FOUNDATION INVESTIGATION REPORT

Millhaven Creek Bridge, Odessa

W.P. 35-73-03, Site 17-79

Re: Millhaven Creek Bridge
W.P. 35-33-03, Site 17-79
Hwy. 2, District 8, Kingston

MILLHAVEN CREEK BRIDGE
in the Village of Odessa
FOOTINGS & RET. WALLS

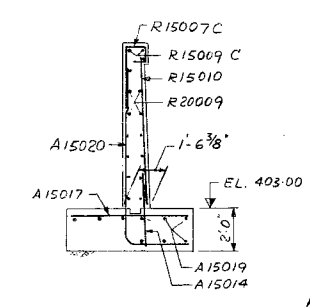
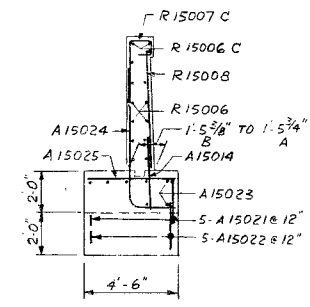
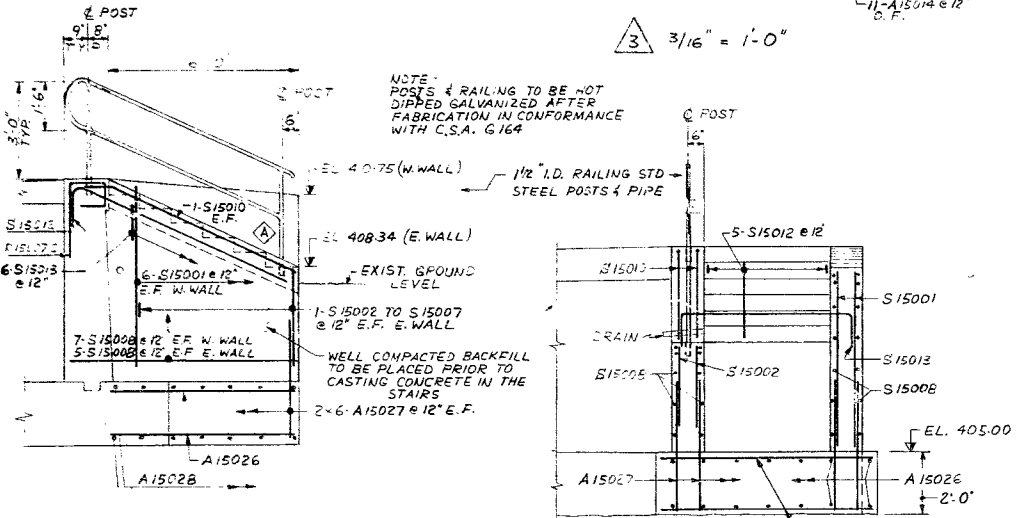
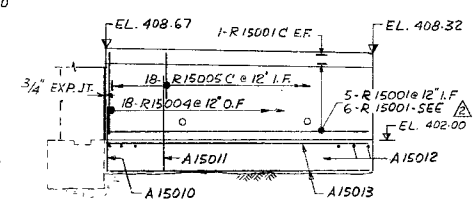
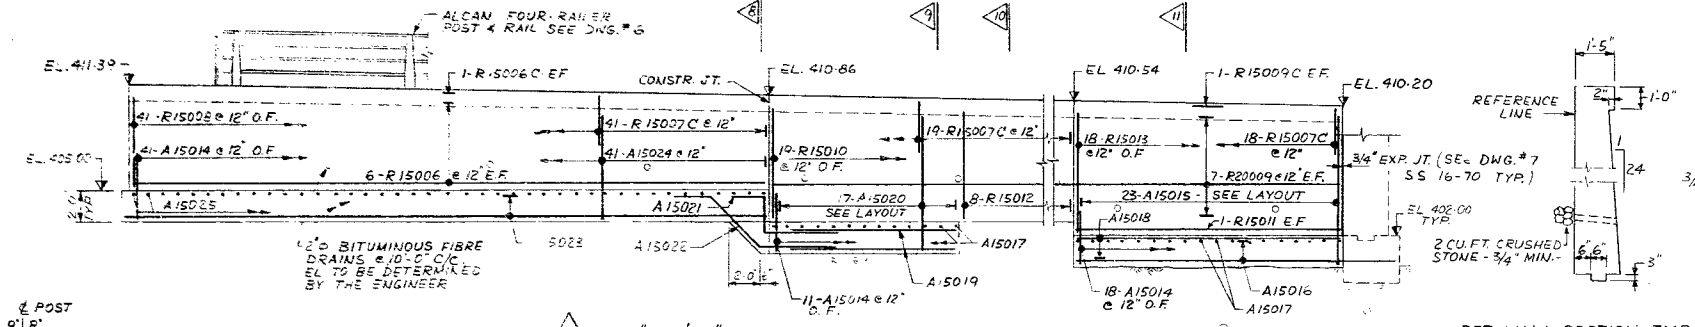
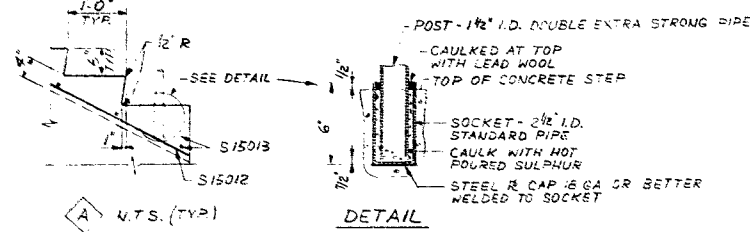
- (a) The 2"Ø wall drain pipe is to be changed to 3".
- (b) The length of bar A15016 is to be reviewed.
- (c) Footing in "Ret. Wall Section-Typ" is to be indicated.

PLAN
SCALE: 1" = 20'-0"

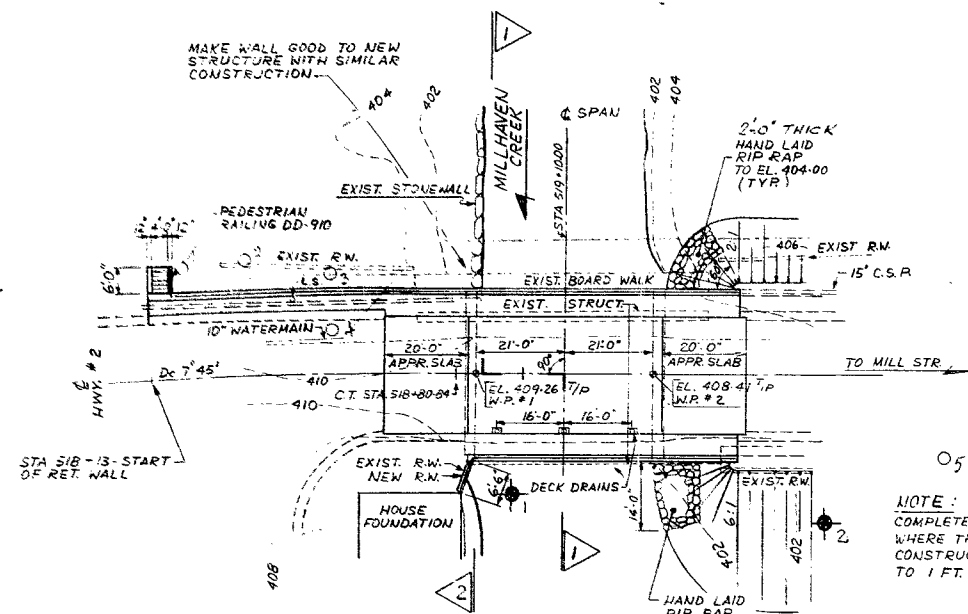
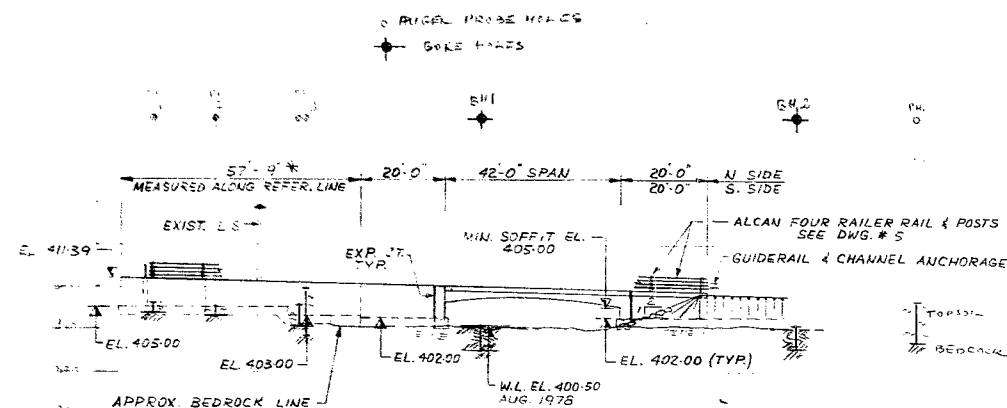
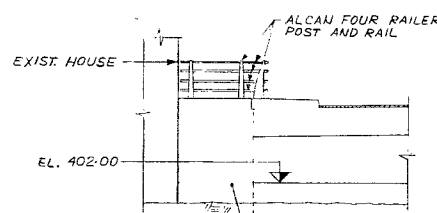
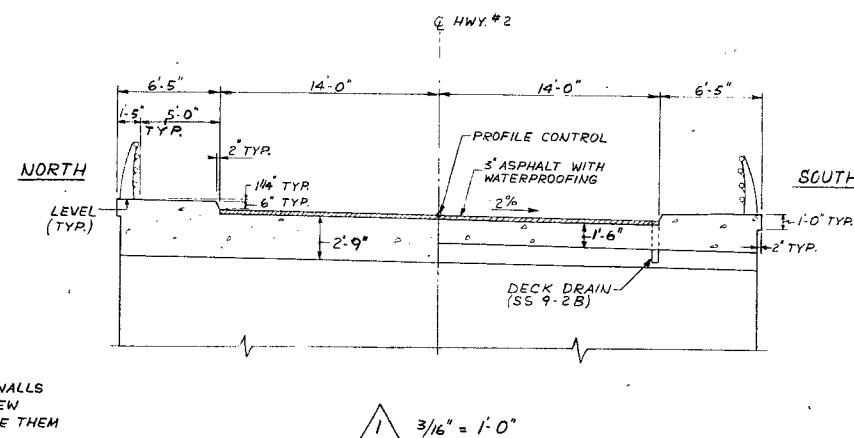
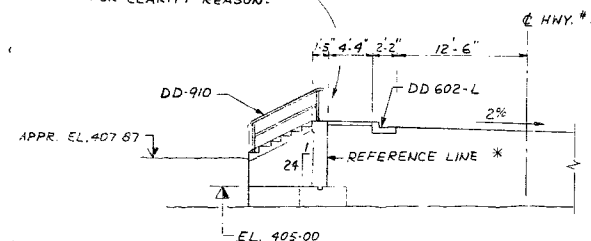
- (a) The existing watermain may interfere with the backfilling operation. The Regional Structural Section is to advise the Design Section of the correct location of watermain.
- (b) Delete concrete quantity for sidewalk and adjust concrete quantities in Bridge and Approach Slabs accordingly.
- (c) Refer to grading drawing for sidewalk adjacent to wingwall.
